**FINAL DRAINAGE REPORT
FOR
STERLING RANCH RECYCLING FACILITY**

**February 2024
Project No. 25188.14
PCD Filing No: PPR2341 & SF2325**

**Prepared By:
JR Engineering, LLC
5475 Tech Center Drive, Suite 235
Colorado Springs, CO 80919
719-593-2593**

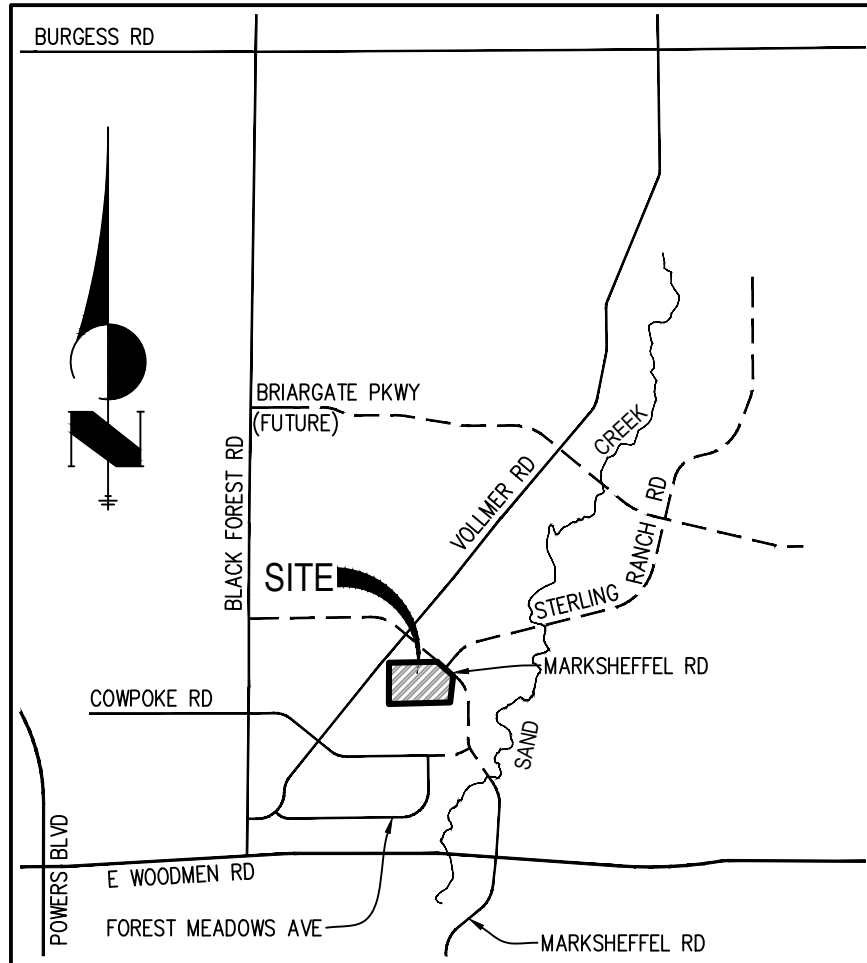
Per my comment on the FAE Form, please provide a separate table that summarizes just the cost of pond components. The total should match what is shown on the FAE Form (currently \$170k). My previous Review 1 comment is provided below for reference.

COST ESTIMATE
 Include a cost estimate for each PBMP with line items for all components (ex: riprap, road base, forebay, trickle channel, outlet structure, outlet pipe, spillway, etc). Input the total value into the FAE form under "Permanent Pond/BMP (provide engineer's estimate)" in Section 1. The total should not include grading, which is a separate line item in Section 1: "Earthwork."

JR Response: Provided separate cost estimates for the drainage infrastructure items as well and the pond items. Coordinated values with the FAE.

PCD FILE NO. PPR2341 & SF2325
STERLING RANCH RECYCLING FACILITY
PROPOSED DRAINAGE MAP
JOB NO. 25188.14
02/09/2024
SHEET 1 OF 1

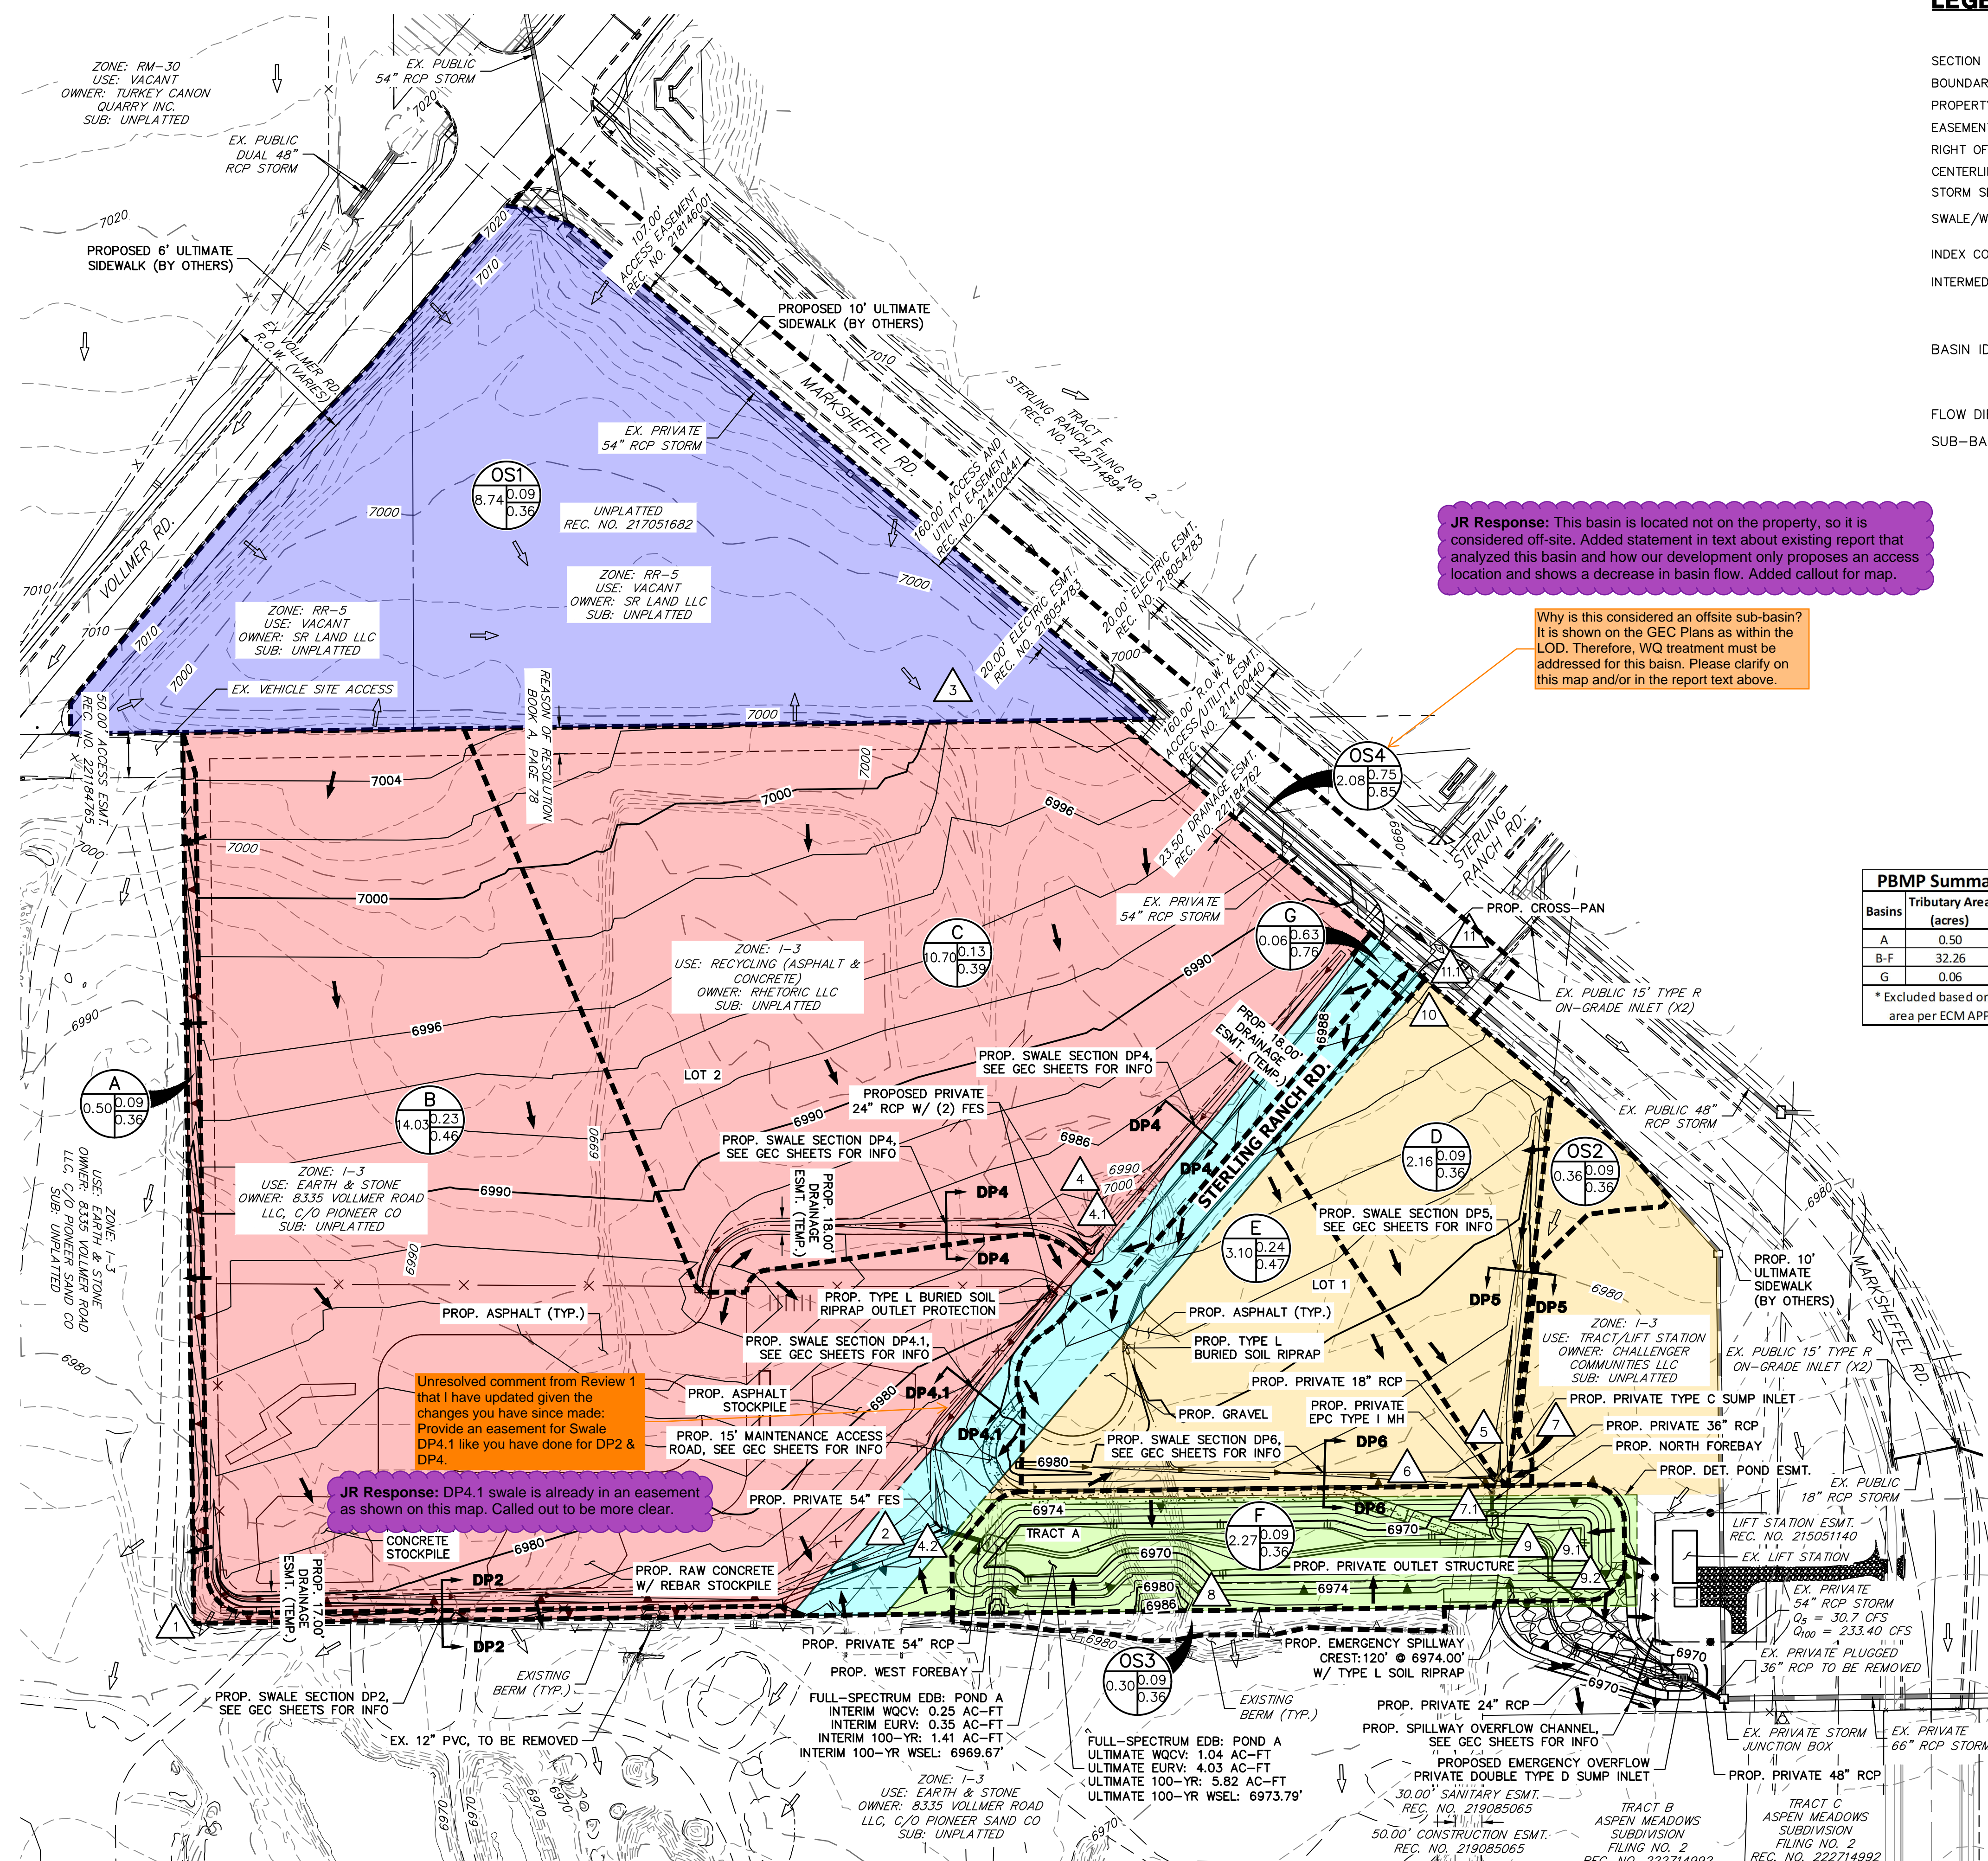
Why is this considered an offsite sub-basin?
It is shown on the GEC Plans as within the LOD. Therefore, WQ treatment must be addressed for this basin. Please clarify on this map and/or in the report text above.

Unresolved comment from Review 1 that I have updated given the changes you have since made: Provide an easement for Swale DP4.1 like you have done for DP2 & DP4.

JR Response: This basin is located not on the property, so it is considered off-site. Added statement in text about existing report that analyzed this basin and how our development only proposes an access location and shows a decrease in basin flow. Added callout for map.

JR Response: DP4.1 swale is already in an easement as shown on this map. Called out to be more clear.
